UNITED STATES
NUCLEAR REGULATORY COMMISSION
WASHINGTON, D.C. 20555-0001

SUBJECT: BRUNSWICK STEAM ELECTRIC PLANT, UNITS 1 AND 2 - STAFF
ASSESSMENT OF INFORMATION PROVIDED PURSUANT TO TITLE 10 OF
THE *CODE OF FEDERAL REGULATIONS* PART 50, SECTION 50.54(f),
SEISMIC HAZARD REEVALUATIONS FOR RECOMMENDATION 2.1 OF THE
NEAR-TERM TASK FORCE REVIEW OF INSIGHTS FROM THE FUKUSHIMA
DAI-ICHI ACCIDENT (CAC NOS. MF3824 AND MF3825)

STAFF ASSESSMENT BY THE OFFICE OF NUCLEAR REACTOR REGULATION

BRUNSWICK STEAM ELECTRIC PLANT, UNITS 1 AND 2

Figure 3.3-1 Plot of Staff's and Licensee's Base Case Shear-Wave Velocity Profiles for the Brunswick Site

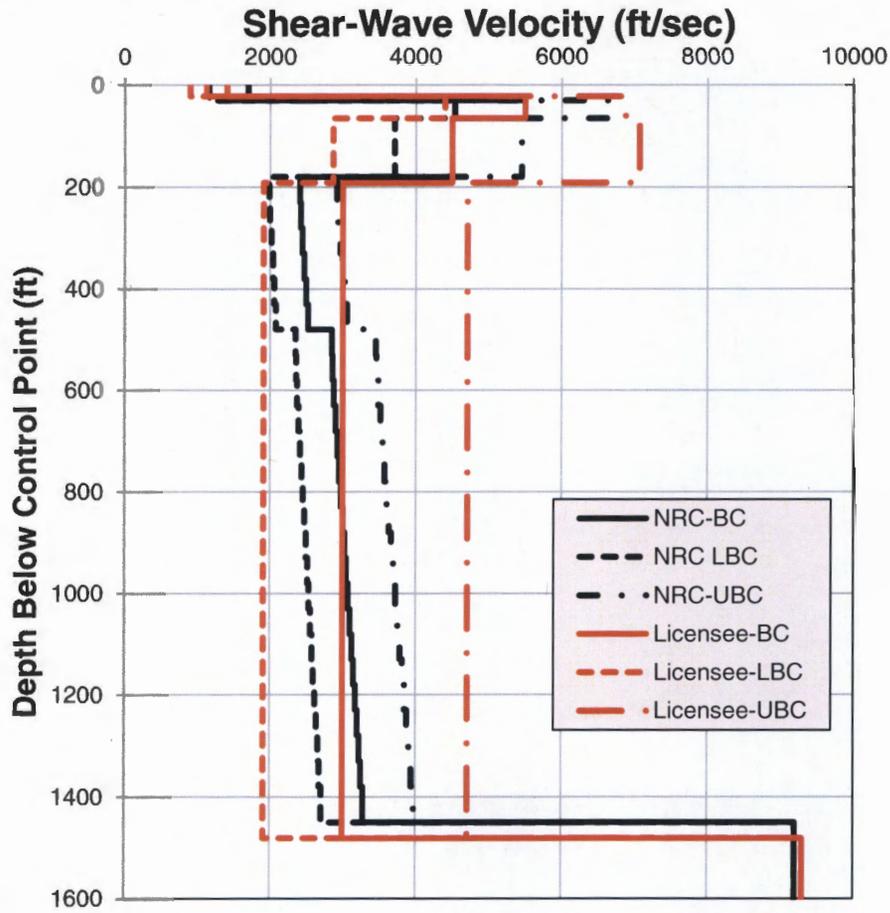
The licensee developed a shear wave velocity profile from the surface to the top of the Peedee Limestone based on seismic refraction surveys and limited borehole measurements made at the Brunswick site. For the material underlying the Peedee Limestone, the licensee assumed a constant shear wave velocity of 3,000 ft/sec (915 m/sec) down to the basement rock at a depth of 1,500 ft (457 m). To capture the uncertainty in the shear wave velocities for the material beneath the site, the licensee developed lower and upper base case shear-wave velocities using a scale factor of 1.25 for the Yorktown Formation and Oligocene Sediments and 1.57 for deeper units, representing a natural log standard deviation of 0.17 and 0.35 respectively. Table 2.3.2-1 and Figure 2.3.2-1 of the SHSR provide the licensee's shear-wave velocity profile for each of the three base case profiles. Figure 3.3-1 of this assessment shows the licensee's three shear-wave velocity profiles.

To capture the uncertainty in the site subsurface geology, the NRC staff developed three base case shear-wave velocity profiles. The best estimate base case shear-wave velocity profile is based on the information obtained from Figure 2-40 of the Brunswick, Units 1 and 2 UFSAR (Progress Energy, 2012) and the information obtained from other sources for the Castle Hayne, Peedee and Black Creek geologic formations (Odum et al., 2003; SCDOT Geotechnical Design Manual, 2008). The lower and the upper base case profiles were calculated using a scale factor of 1.21, consistent with a natural log standard deviation of 0.15. Figure 3.3-1 of this assessment shows a comparison of the shear-wave velocity profiles developed by the licensee with those developed by the NRC staff. The staff's best estimate base case profile generally demonstrates similar behavior as the licensee's profile except the staff's profile shear-wave velocity increases gradually below the depth of 180 ft [54.9 m] from 1,988 ft/sec (606 m/sec) to 2,709 ft/sec (826 m/sec) at the bedrock depth of 1,450 ft (442 m). The licensee assumed a slightly different depth to bedrock of 1482 ft (452 m). In addition to the differences in the best case profile, for its development of the lower and upper base case profiles, the licensee assumed higher uncertainties of 1.25 for the upper 65 ft (19.8 m) and 1.57 for the deeper part of the profile. As

described below, these differences between the NRC staff's and licensee's profiles did not have a significant impact on the final hazard curves or GMRS for the site.

Figure 3.3-2 Plot Comparing the Staff's and the Licensee's Median Amplification Functions and Uncertainties for the Brunswick site.

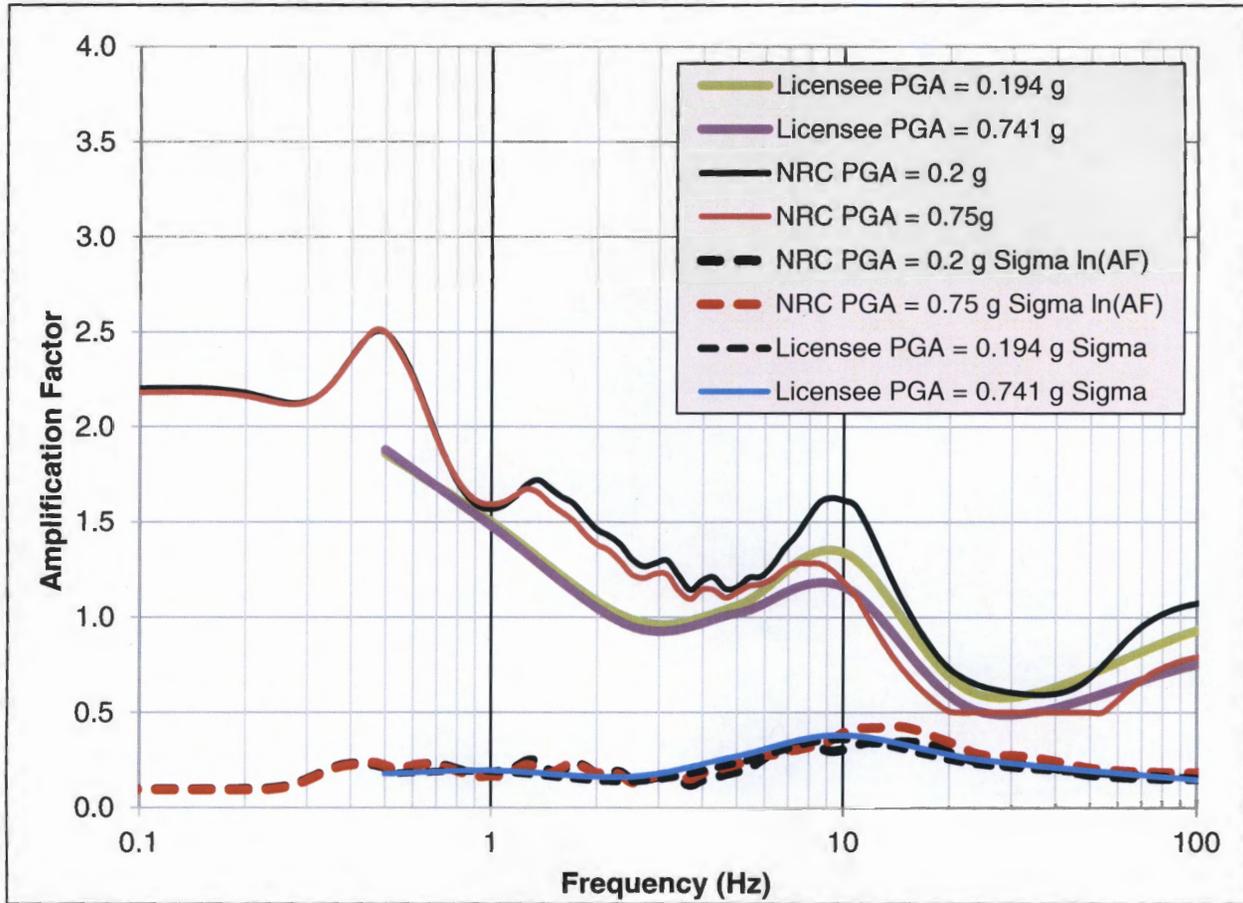
Figure 3.3-2 of this assessment shows a comparison of the staff's and licensee's median site amplification functions and uncertainties (± 1 standard deviation) for 2 of the 11 input loading levels. Due to the differences in shear-wave velocity profiles and kappa, the staff's amplification functions are slightly higher than those of the licensee. However, overall the licensee's approach to modeling the subsurface rock properties and their uncertainty results in amplification factors that are very similar to those developed by the NRC staff. In addition, as shown in Figure 3.3-3 of this assessment, the minor differences in the licensee's and staff's site response analyses lead to control point seismic hazard curves that are very similar. Appendix B of the SPID provides guidance for performing site response analyses, including capturing the uncertainty for sites with less subsurface data; however, the guidance is neither entirely prescriptive nor comprehensive. As such, various approaches in performing site response analyses, including the modeling of uncertainty, are acceptable for the 50.54(f) response.

Figure 3.3-3 Plot Comparing the Staff's and the Licensee's Mean Control Point Hazard Curves at a Variety of Frequencies for the Brunswick site

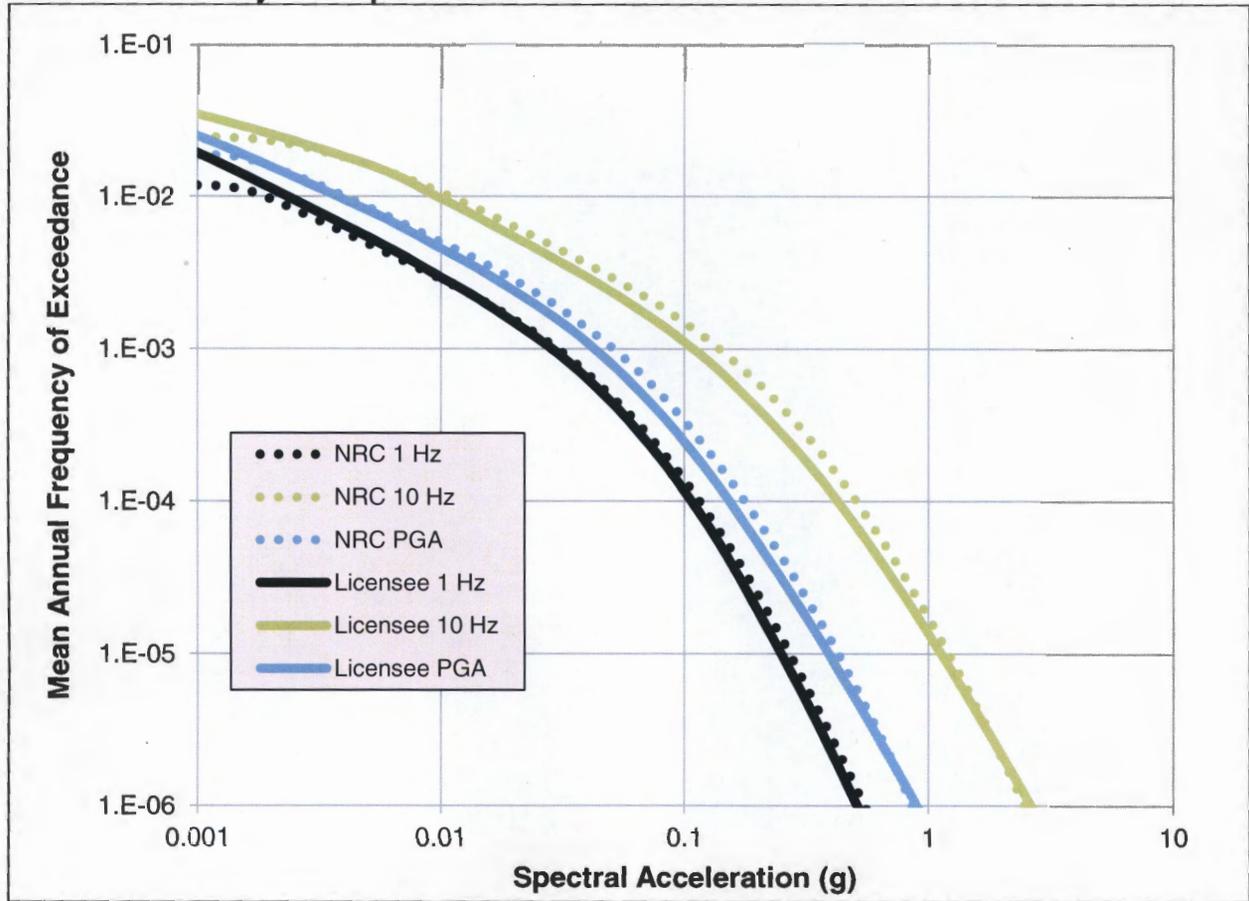
In summary, the NRC staff concludes that the licensee's site response was conducted using present-day guidance and methodology, including the NRC-endorsed SPID. The NRC staff performed independent calculations which confirmed that the licensee's amplification factors and control point hazard curves adequately characterize the site response, including the uncertainty associated with the subsurface material properties, for the Brunswick site.

Figure 3.4-1 Comparison of the Staff's GMRS with Licensee's GMRS and the SSE for the Brunswick site

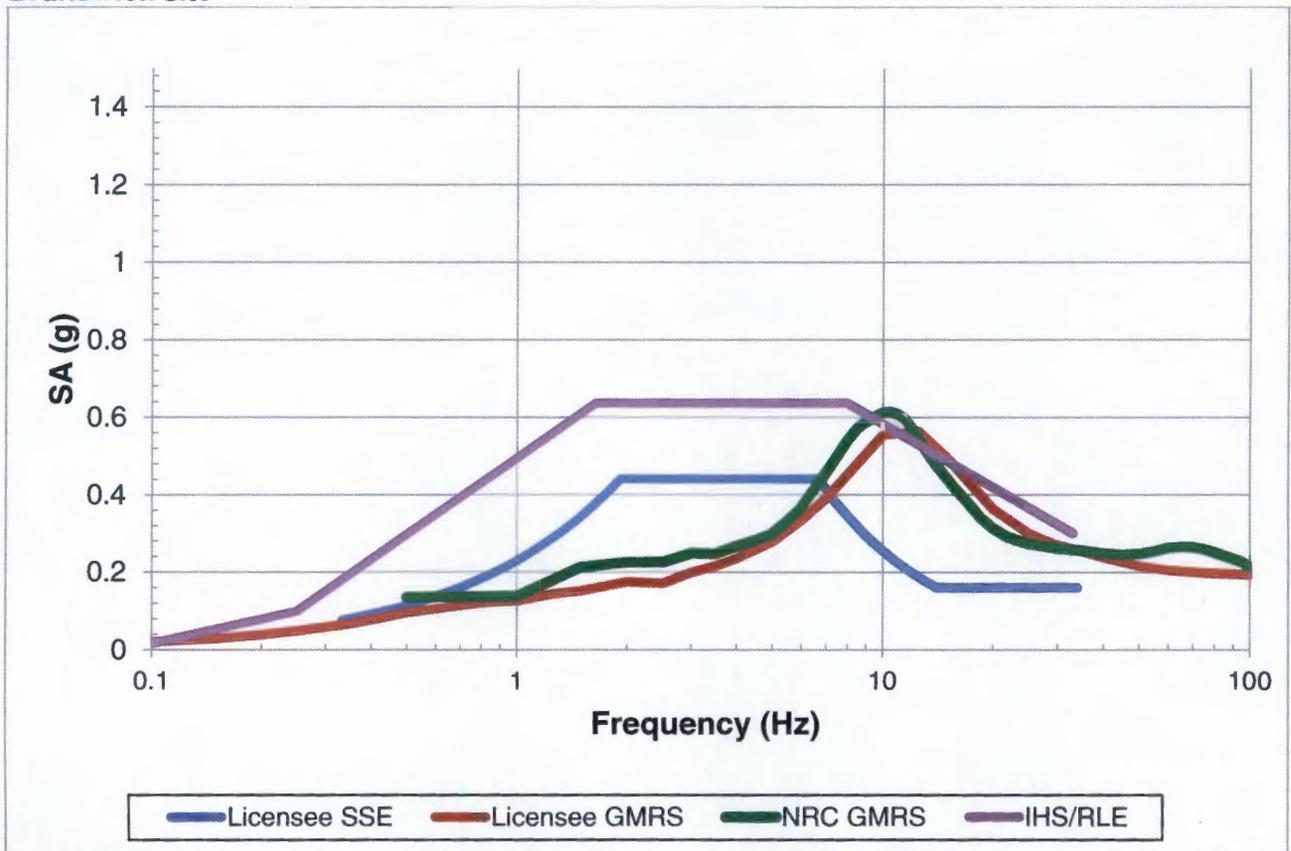
assessment, respectively. Figure 3.4-1 of this assessment shows a comparison of the GMRS determined by the licensee to that determined by the NRC staff.

As shown in Figure 3.4-1, the licensee's GMRS shape is generally similar to that calculated by the NRC staff. These minor differences in GMRS are the result of differences in the site response analyses performed by the licensee and NRC staff as discussed in Section 3.3 above.

In reaching this determination, the NRC staff confirms the licensee's conclusion that the licensee's GMRS for the Brunswick site is bounded by the IHS or SSE over the frequency range of 1 to 9 Hz. Between 9 and 10 Hz the NRC staff verified that the licensee's GMRS exceeds the IHS by a slight amount; however, the exceedance falls within the narrow-band-exceedance criteria specified in the SPID. Therefore, as stated in the October 27, 2015, letter, a seismic risk evaluation (Item 8) is not requested. The NRC staff confirmed the licensee's conclusion that it will perform an IPEEE relay chatter review to complete the criteria for using its IPEEE program for screening purposes. Because the GMRS exceeds both the IHS and SSE for a portion in the frequency range above 10 Hz, a HF confirmation is merited. Finally, because the IPEEE program did not include the SFP and the GMRS exceeds the SSE between 1 to 10 Hz, a SFP evaluation is merited.
